**END OF BID ADDENDUM No.1**

DRAWING NAME:  
**EMERGENCY KEY BOX**

PROJECT NAME:  
**THE WILLIAMS**  
 20 SOUTH LONG STREET  
 WILLIAMSVILLE, NY 14221

1 PLAN DETAIL - EMERGENCY KEY BOX  
 SK-A03 SCALE: 1 1/2" = 1'-0"

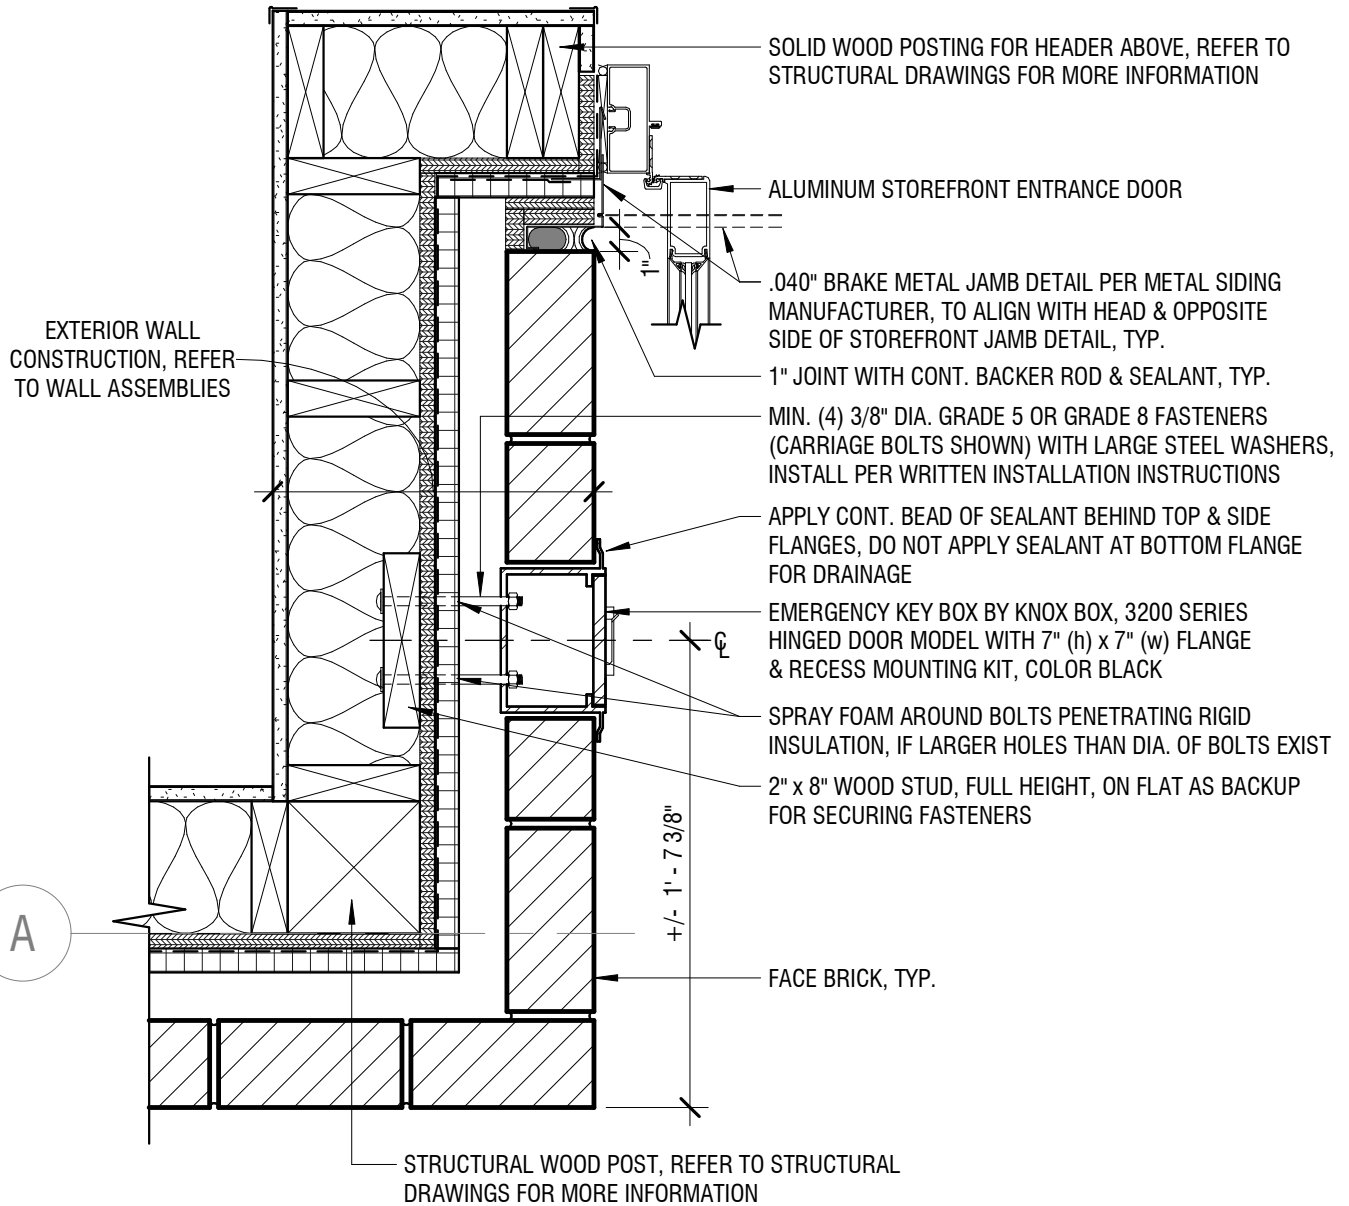
- A. The elevator specified and to be installed is a 3,500 lb. capacity, front side opening with 42" wide doors per floor. The elevator is required by code to accommodate a 24" x 84" stretcher.
- B. An emergency key box is to be provided and installed on the exterior façade at the first floor lobby entrance. See attached construction sketch SK-A03 for more information.

1. REFER TO THE KNOX COMPANY GENERAL MOUNTING INSTRUCTIONS FOR ALL OTHER MOUNTING REQUIREMENTS NOT DEPICTED IN THIS SKETCH.
2. RECOMMENDED MOUNTING HEIGHT ABOVE FINISHED FLOOR/GRADE TO BE 6'-0" AS PER THE KNOX COMPANY.
